City of Santa Fe, New Mexico

DATE: December 10, 2024
TO: Historic Districts Review Board Members
FROM: Lani McCulley, Senior Planner, Historic Preservation Division

2024-009479-HDRB, 710 Canyon Rd., Downtown & Eastside Historic District, Contributing, Conron & Woods Architects, agent for Anna Marie Hamilton, owner, proposes to remove a portion of the portal, raise parapets, relocate a door, re-roof the portal and residence, replace skylights and canales, stucco, and hardscape. An exception is requested to 14-5.2 (D)(6) to replace the roof not in-kind.

Figure 1: North Street Facing Elevation: Primary Facade

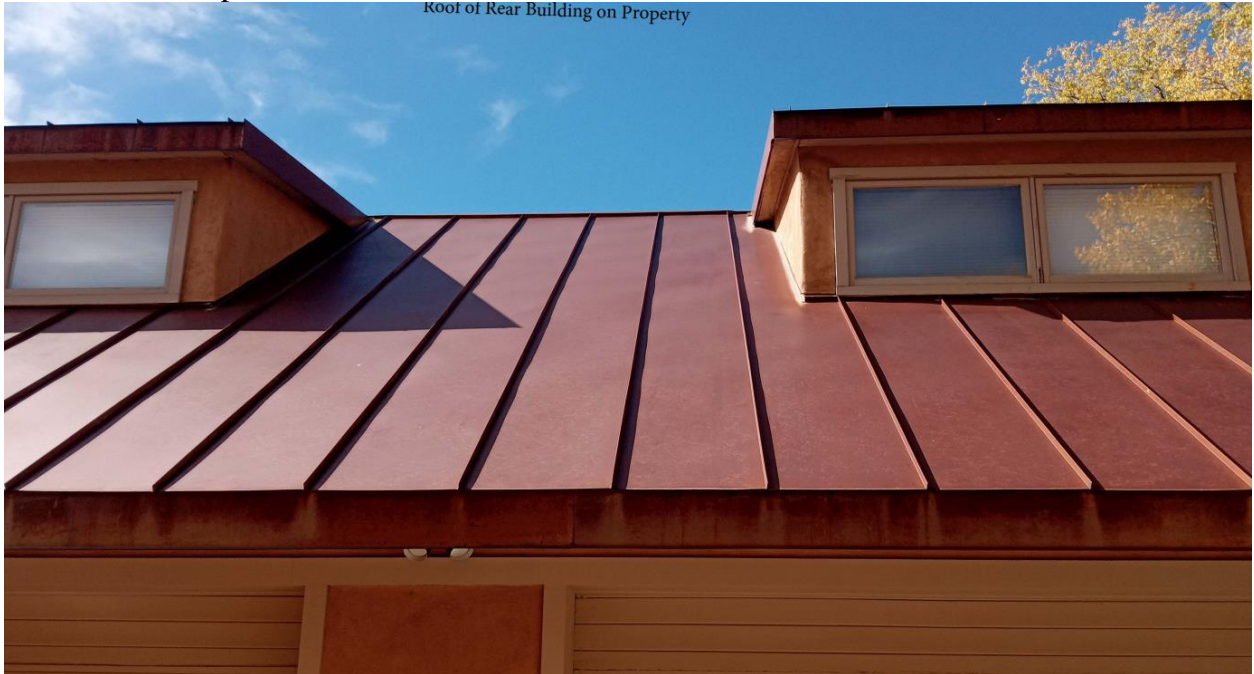
In October 2024, the HDRB assigned the north elevation as the primary façade due to the craftsman influence of unpainted patterned shingles, narrow wood windows, knee braces, pediments, terneplate roof, and thick adobe walls.

1. Replace the 3,475 sq. ft. of existing terneplate or crimped metal roofing with a standing seam roof in reddish brown color. An exception is requested to section 14-5.2(D)(6) to replace the roof in a material that is not in-kind.

Staff Response: Staff agrees with this response. There are several pitched roofs on Canyon in this streetscape that have standing seam roofs in browns and reds.

Staff Response: The Applicant has not addressed this approval criteria. While the 3V crimped is not available, a similar product the 5V crimped is available and would more closely matched the style and material of the existing roof.

Staff Response: The heterogenous character of the city is built upon the diversity of materials and styles on individual lots, among adjacent lots and along streetscapes. While staff understands that a metal roof is more in-keeping with other buildings of the property, the terneplate 3V crimped roof is a component of the building’s contributing status and while that exact material is not available the closest available option or the 5V crimped roof would be more in-keeping with the current style of the roof and strengthen and maintain the heterogeneous character of the city.

Staff finds that the exception criteria have not been met and recommends denial of the exception to replace the roof not in-kind. Otherwise, staff recommends approval of the applicant's requested items 2-11 (see Applicant Request) as they comply with 14-5.2(D) General Design Standards for all Historic Districts, and 14-5.2(E) Downtown and Eastside Design Standards. Two motions will be required in this case.
